SERVICE BULLETIN

SB_SPXP_010
Revision 00

SB_SPXP_010 Engine Cooling Baffle

Installation of an engine cooling baffle.

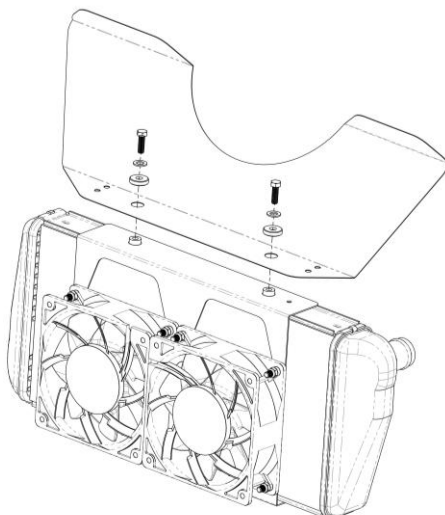
- Remove engine cowlings.
- Remove the upper bolts, washers and bushings that fix the aluminum support of the engine cooling fans (see picture below).

The aluminum support do not need to be removed.
